Statesville Office (704) 878-5305 | Mooresville Office (704) 660-3625 | PERMIT # 240844

SEPTIC IMPROVEMENT PERMIT / AUTHORIZATION TO CONSTRUCT / OPERATION PERMIT / EXISTING SYSTEM

Attached is a proposed design for a 25% / 50% reduction Septic System with Gravity distribution for a 4 bedroom single family residence on Section 7 Lot 127 of CL&T, 132 Rollingwood Ln., Iredell County, North Carolina.

132 ROLLINGWOOD LN.
DESIGN SPECIFICATIONS

INITIAL SITE SKETCH

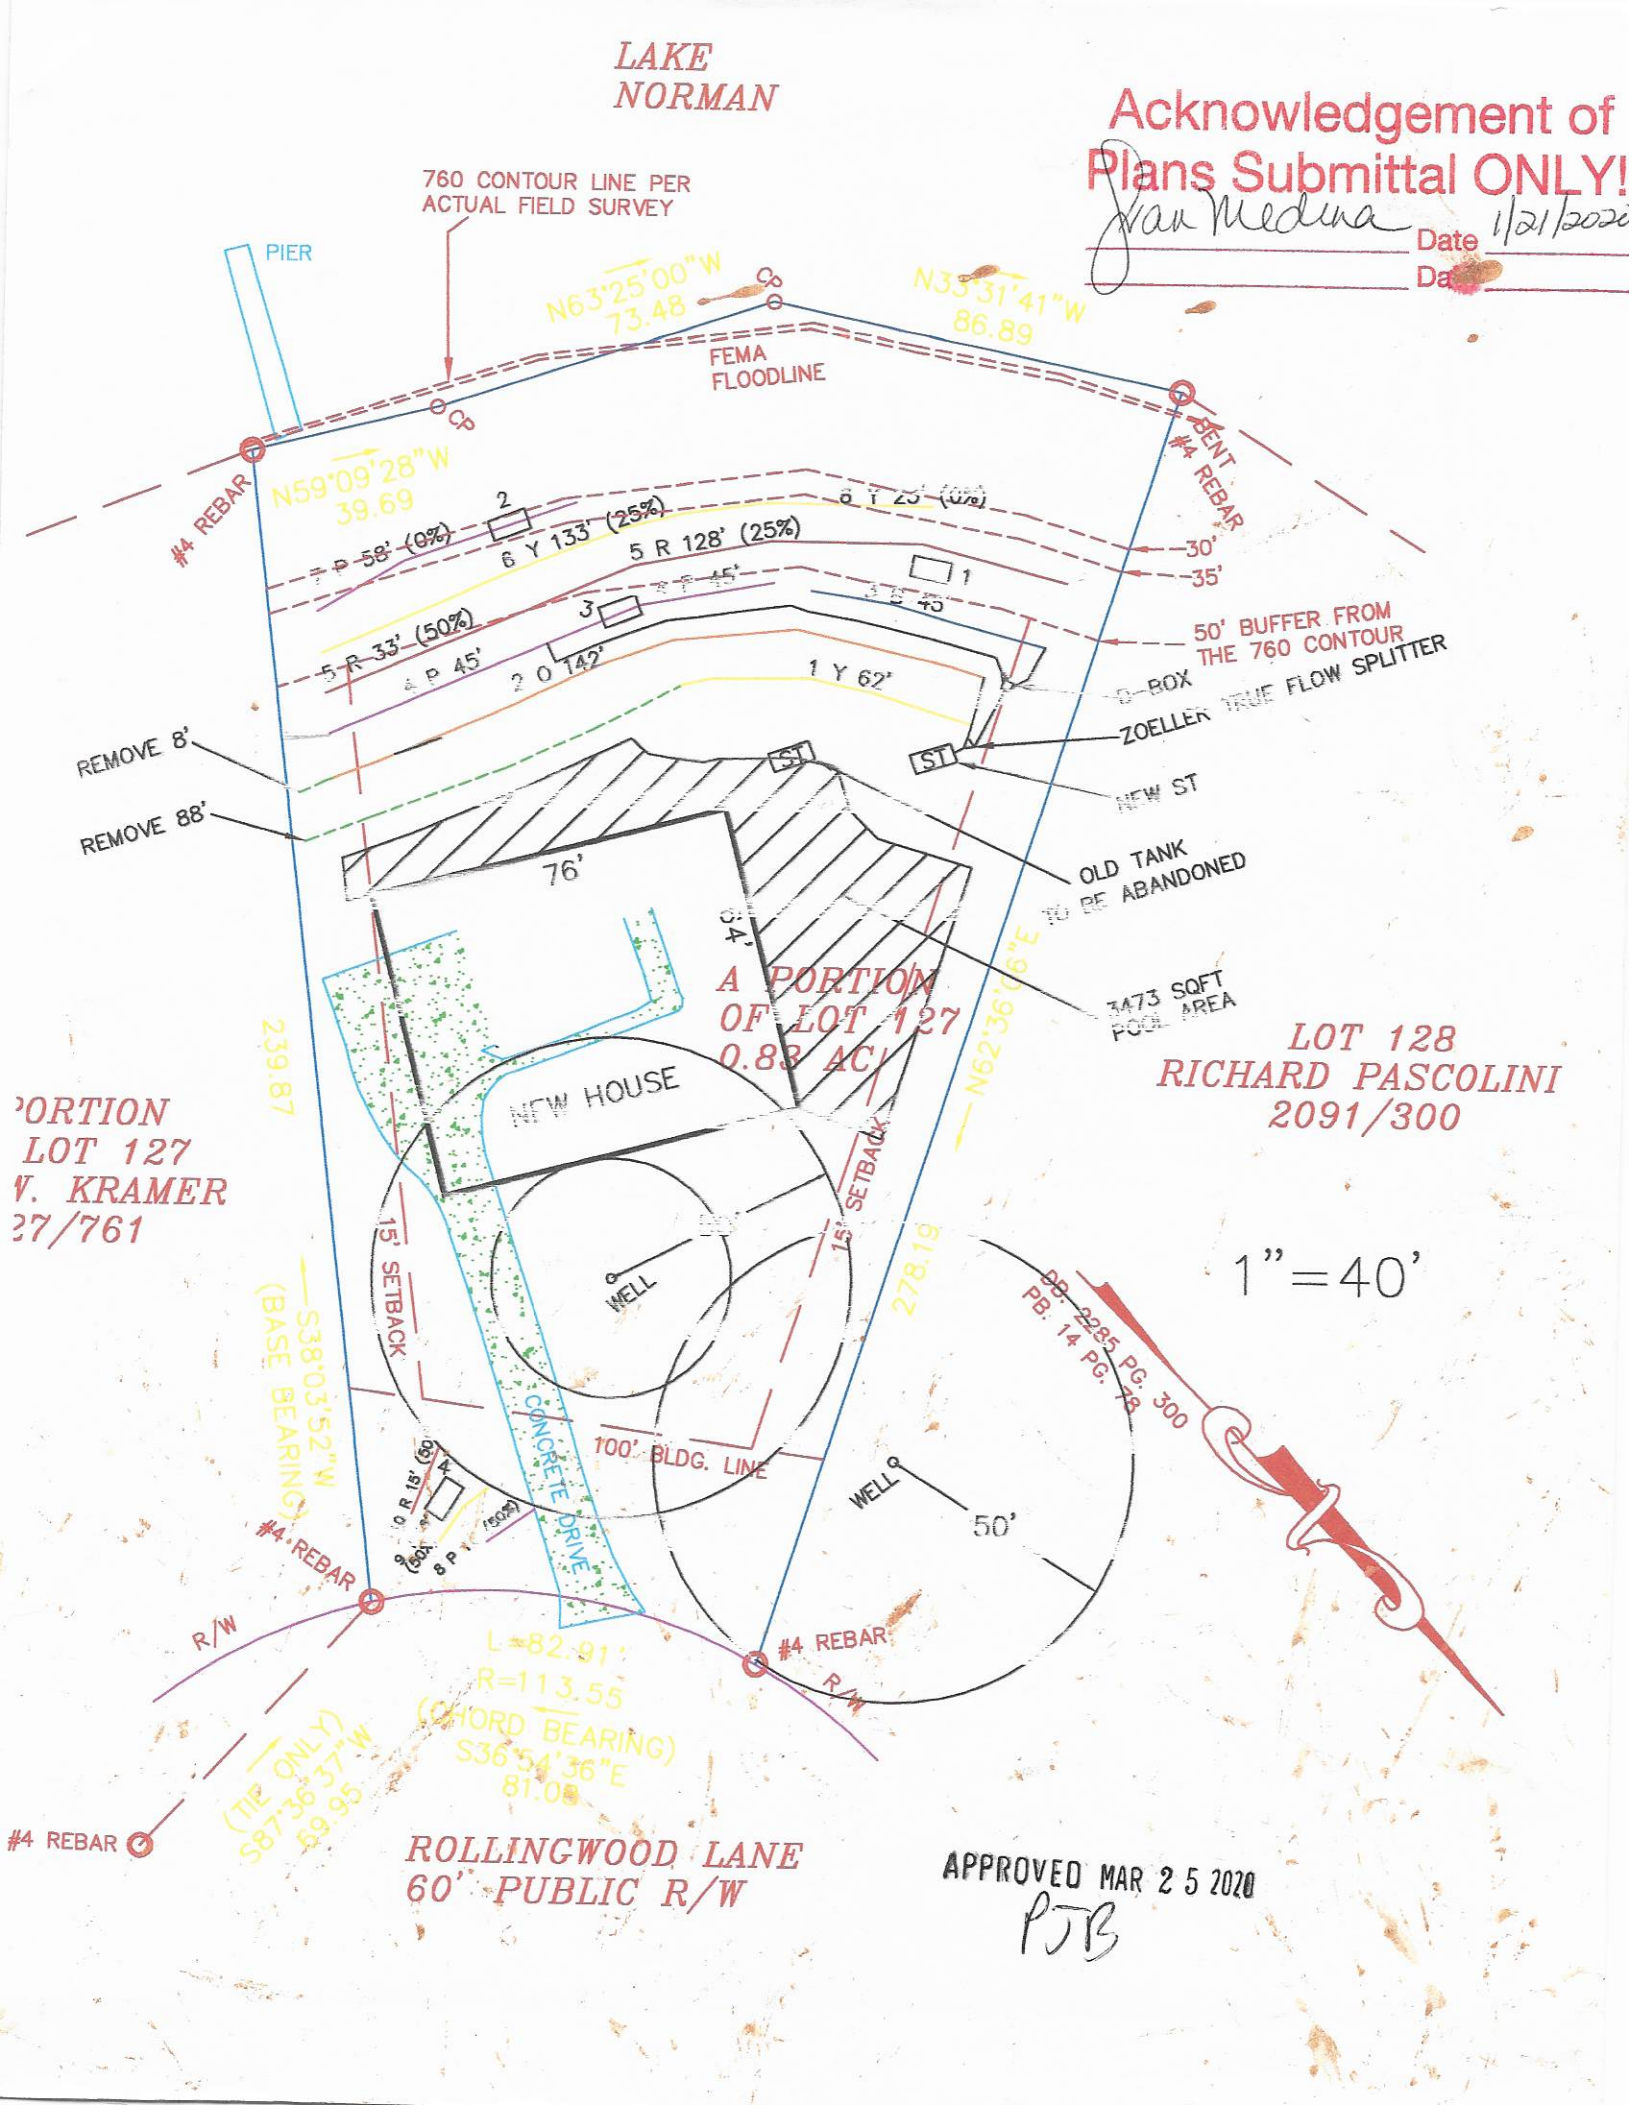
Comments / Conditions: Install drainlines on 1st or 2nd tier. Use caution when removing deck. Property Lines, corners and 50' Buffer must be marked by a licensed Surveyor during time of installation and inspection. Recommend having pool location marked during installation, cutter for basement cannot extend into drainfield. Any part of septic must be 15' aff water edge of pool. DO NOT drive on, store material or maneuver over drainfield. Olds and lengths of

See attached and Approved Site plan by CSandSC 3/31/2020 See Comments made by LSS

Drain lines must be properly abandoned.

NEED FILTER + D-BOXS

12/15/2020: Filter inst, D Boxes all have fall and were connected.
